PERMIT MODIFICATION APPROVAL

Re: Permit Modification Approval for API Number 1706283 , Well #: SWIGER UNIT 2H
Changed Orientation of Lateral

Antero Resources Corporation (Antero) would like to submit the following permit modifications for two approved wells on the existing Stewart Pad. We are requesting to move the horizontal lateral which will change the bottom hole location of the Swiger Unit 1H (API# 47-017-06273), and Swiger Unit 2H (API# 47-017-06283).

API# 47-017-06283 PERMIT MODIFICATION

FILE NO: 78-30-NM-13
DRAWING NO: 78-13 Swiger 2H Well
SCALE: 1" = 1500'
MINIMUM DEGREE OF ACCURACY: Submeter
PROVEN SOURCE OF ELEVATION: WVDOT, Bridgeport, WV

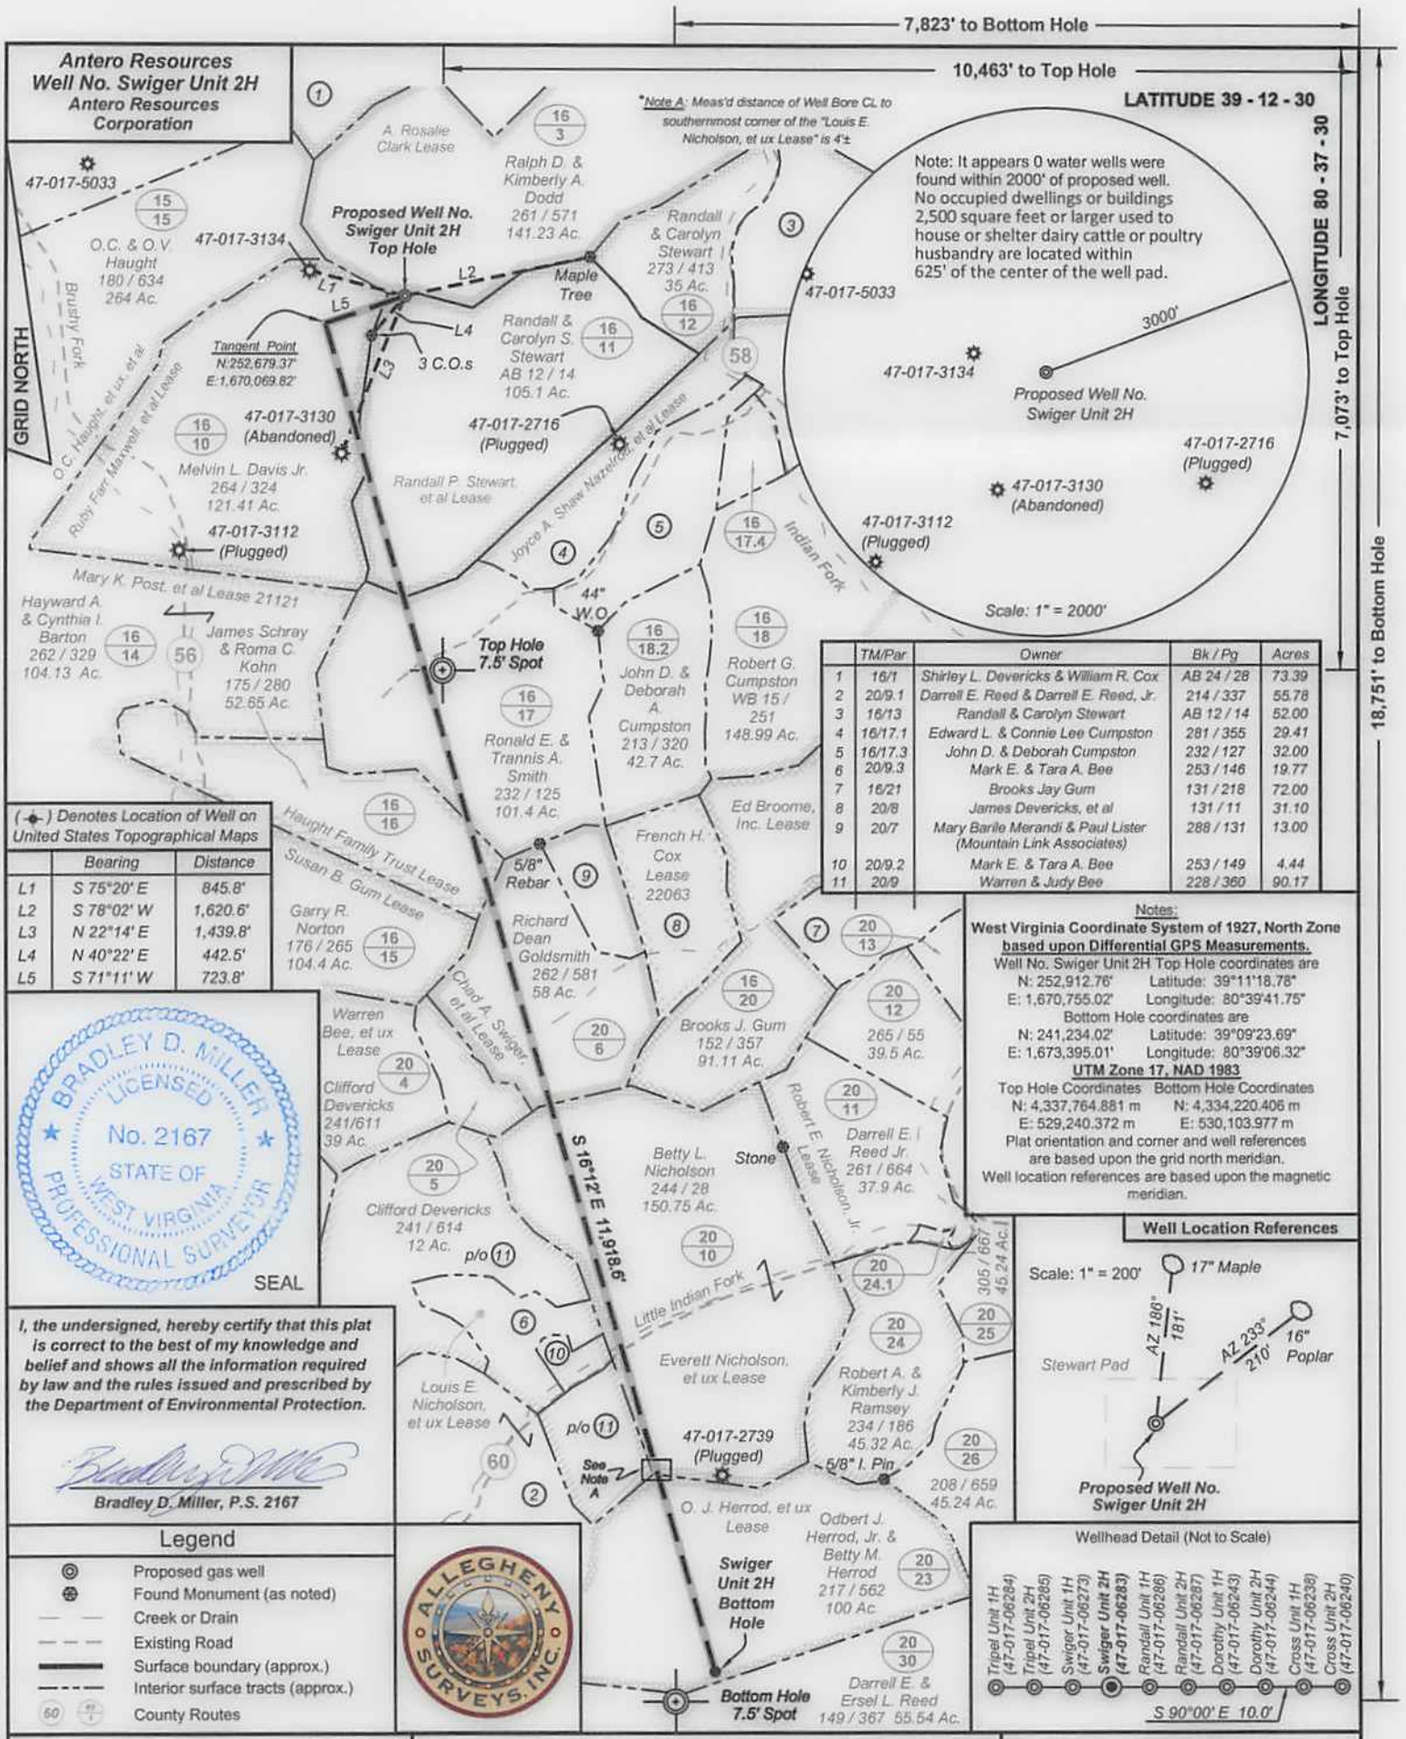
- REVISED Form WW-6B, which shows the revised MD and Production Casing/Cement program
- REVISED Form WW-6A1, which shows the leases we will be drilling into
- REVISED Mylar Plat, which shows the new bottom hole location

Notes:
West Virginia Coordinate System of 1927, North Zone based upon Differential GPS Measurements.
Well No. Swiger Unit 2H Top Hole coordinates are
N: 252,912.76' Latitude: 39°11'18.78"
E: 1,670,755.02' Longitude: 80°39'41.75"
Bottom Hole coordinates are
N: 241,234.02' Latitude: 39°09'23.69"
E: 1,673,395.01' Longitude: 80°39'06.32"
UTM Zone 17, NAD 1983
